Biala Wind Farm

RESPONSE TO SUBMISSIONS

February 2016

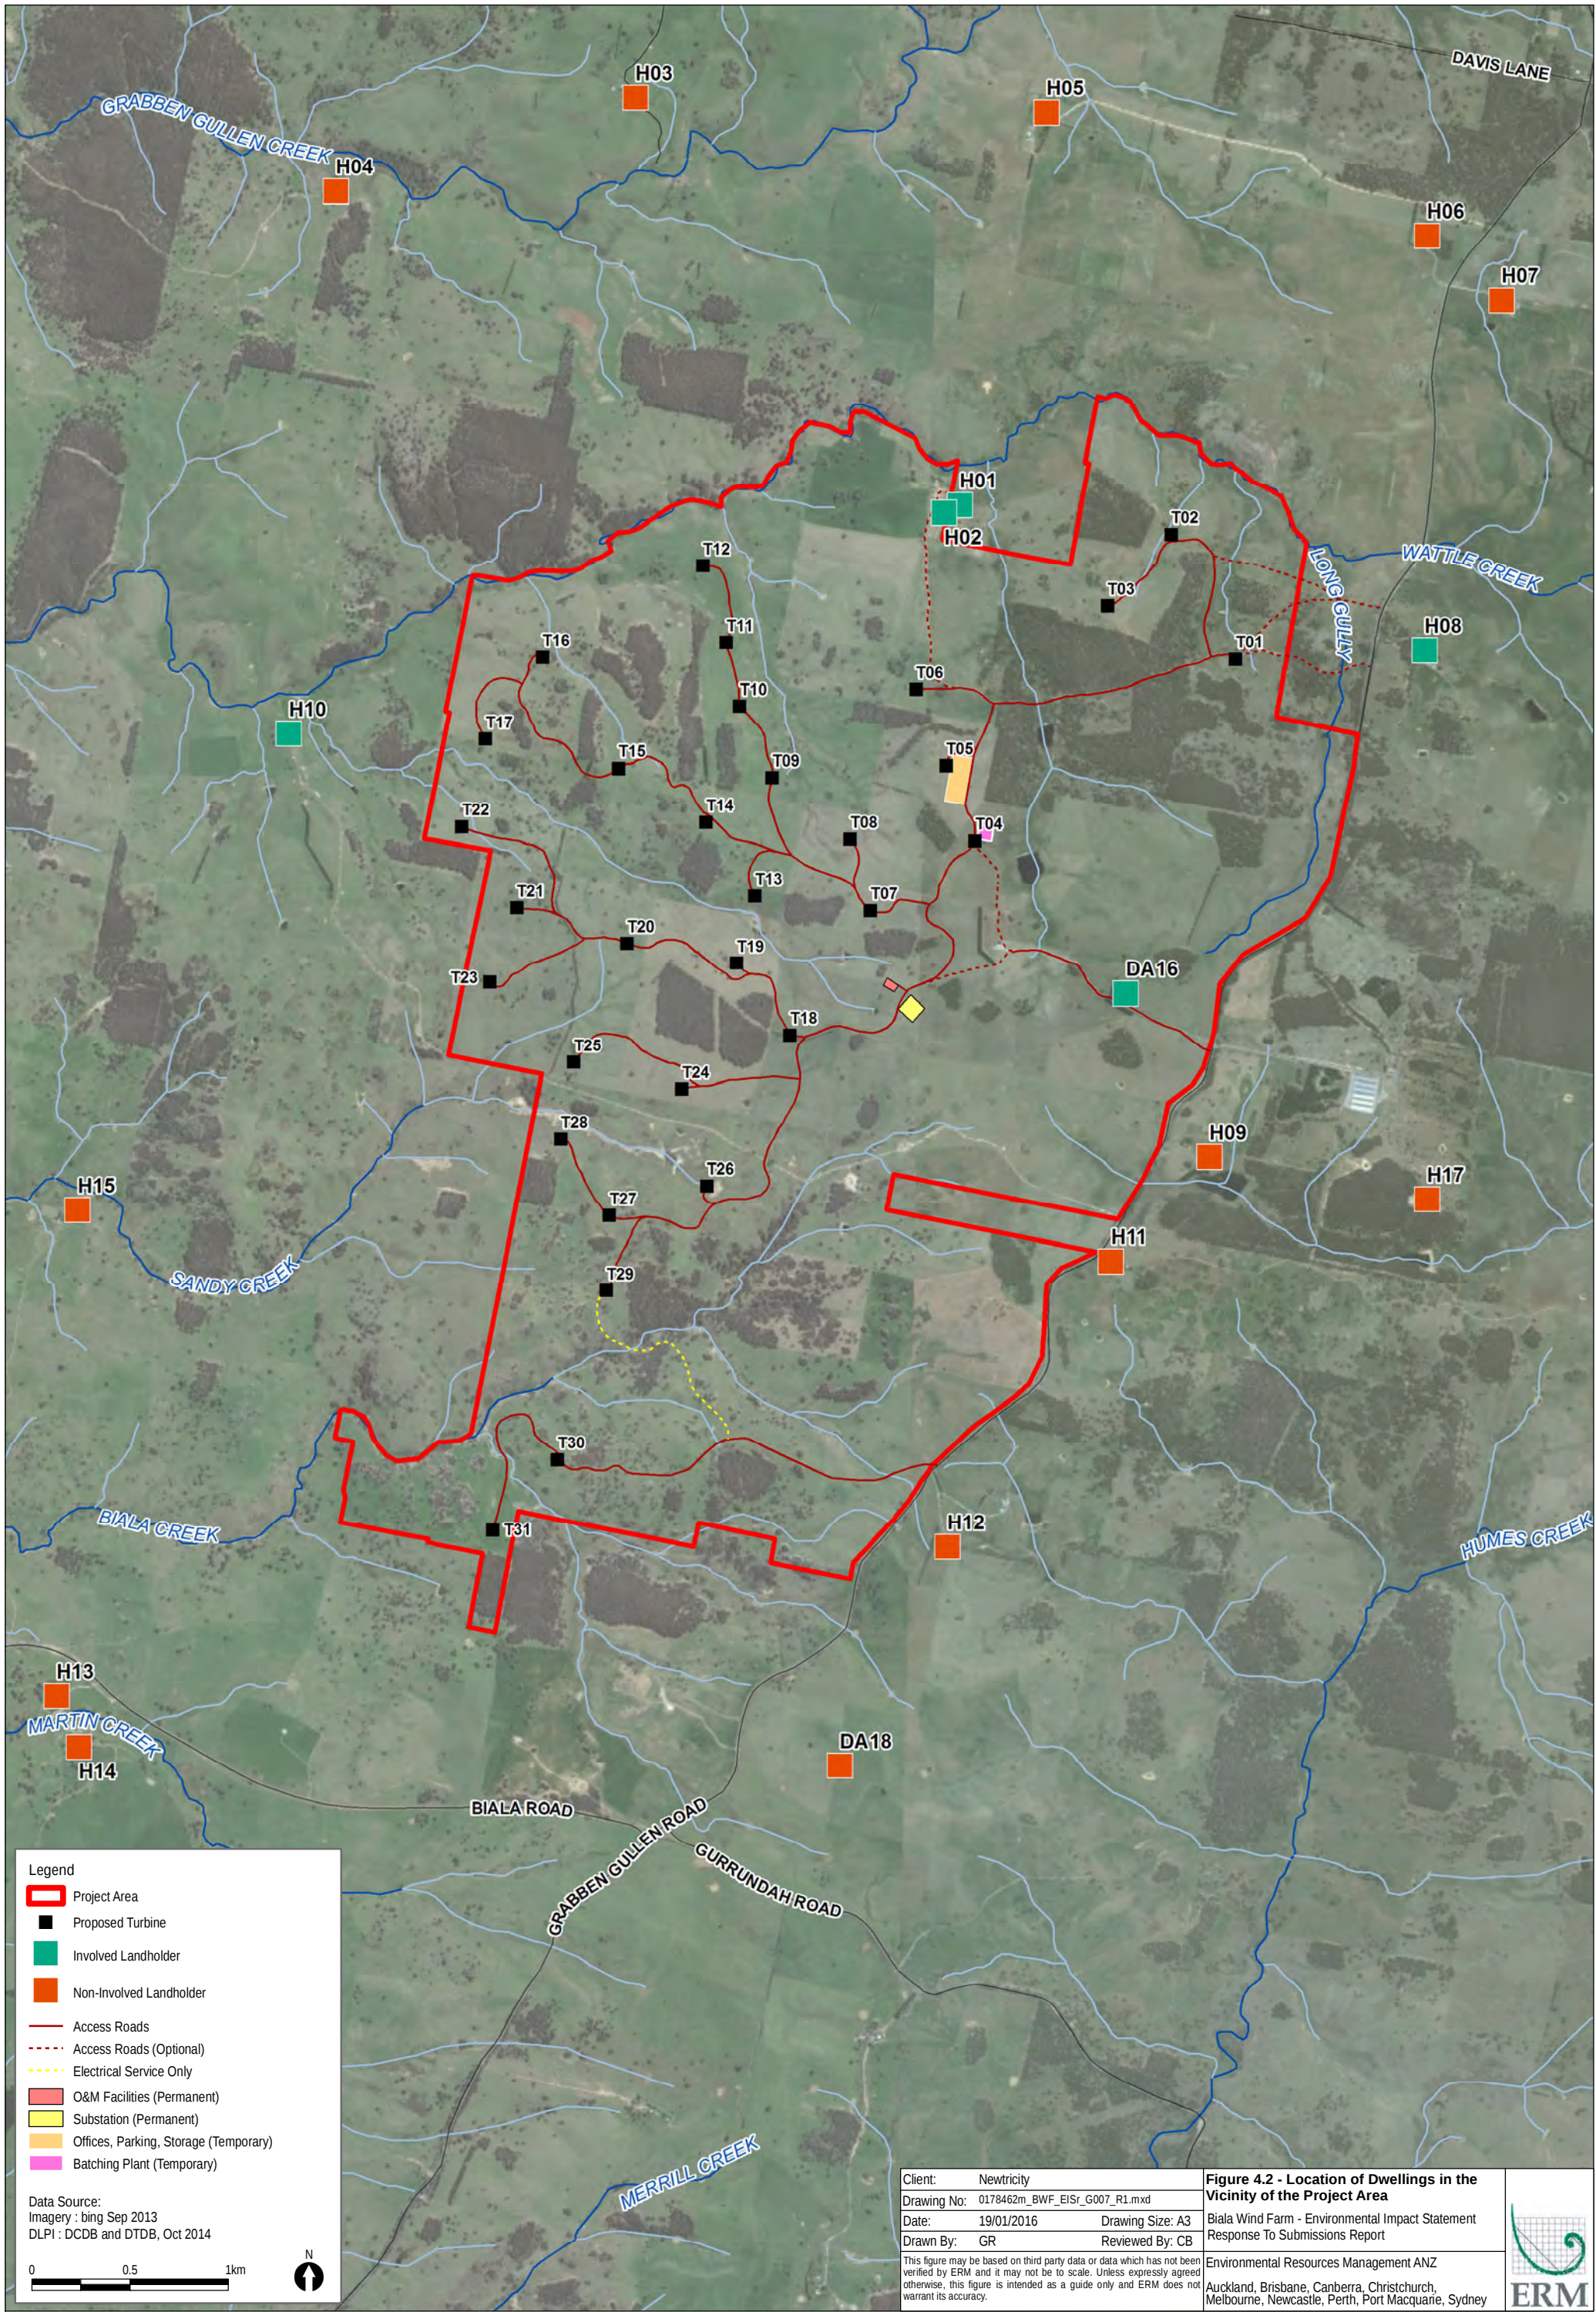
Following submission of the EIS to DPE for public exhibition, the Proponent was made aware of an additional approved residential dwelling (non-involved landholder) in the vicinity of the Project. A copy of the approved DA plan was obtained from ULSC, which indicate that the DA was lodged with ULSC on 29 May 2015 and development consent granted on 17 June 2015. The proposed dwelling is located south east of the Project within Lot 103, DP1174962.

ULSC advised that no coordinates were provided for the proposed dwelling, however some distances are indicated on the approved plans in relation to property boundaries. In order to estimate the position of the dwelling for assessment purposes, the plan provided by ULCS was georeferenced, matching the lot boundaries with the lot boundaries as per the DPLI data set. The estimated location of the proposed dwelling based on this data analysis is summarised in *Table 4.1* and illustrated on *Figure 4-2*, with the dwelling referred to as 'DA18'.

Viewpoint No. and Description	Assessed Level of Impact
Viewpoint 11	Moderate/High
Residential Property - DA18	A review of the topography and vegetation in this area indicates this dwelling will have clear views to the north west with the two closest WTGs clearly visible and blade motion easily discernible. These WTGs will appear large and visually dominant. The upper portions of 11 more WTGs to the north may also be visible, partially obscured by the elevated ridgeline of the hill. Placement of the dwelling in a more elevated position may result in a greater number of WTGs being visible. A view from the peak of the hill would take in all 31 proposed WTGs. This would lead to a visual impact rating of 'High'.

No other significant impacts at this proposed dwelling have been identified as likely to occur as a result of the Project.
